840-846 STEVENS AVENUE

APPLICATION FOR PERMIT
DEPARTMENT OF BUILDING INSPECTIONS SERVICES
ELECTRICAL INSTALLATIONS

BISHOP STREET

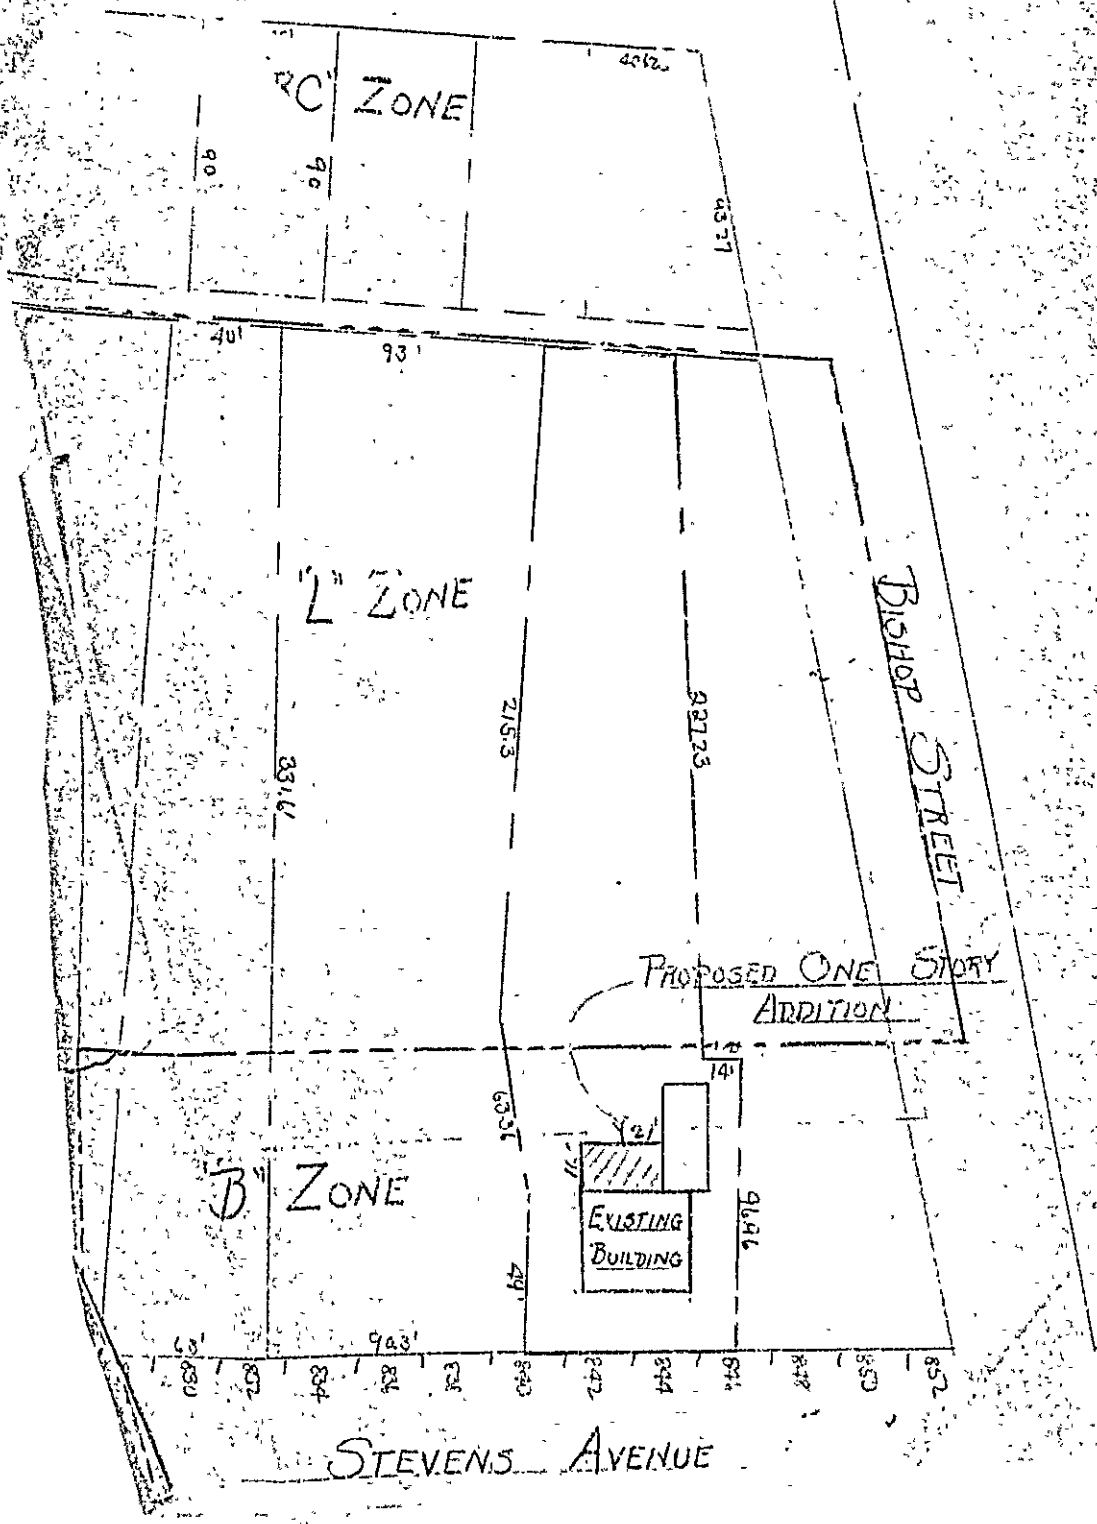
The site plan, submitted, does not indicate the installation of any proposed lighting (exterior lighting in the parking area), however, if lighting is eventually provided, such lighting must be indicated as to eliminate direct illumination into either Stevens Avenue or Bishop Street.

The proposed catch basin located on a plan near the Bishop Street Exit should be constructed to have a minimum three foot (3') deep sump. Also, the plan indicates that the developer intends to direct the effluent from the basin into an existing manhole adjacent to the lot. This existing manhole is a private manhole and is not maintained or controlled by the City. If the developer has permission to enter this private system, then we have no objections.

Drainage: The proposed catch basin located on the plan near the Bishop Street exit should be constructed to have a minimum three foot (3') deep sump. Also, the plan indicates that the developer intends to direct the effluent from the basin into an existing manhole adjacent to the lot. This existing manhole is a private manhole and is not maintained or controlled by the City. If the developer has permission to enter this private system, then we have no objections.

REASONS: Additional Planting Material at the rear of the new parking lot to screen the nearby residential uses
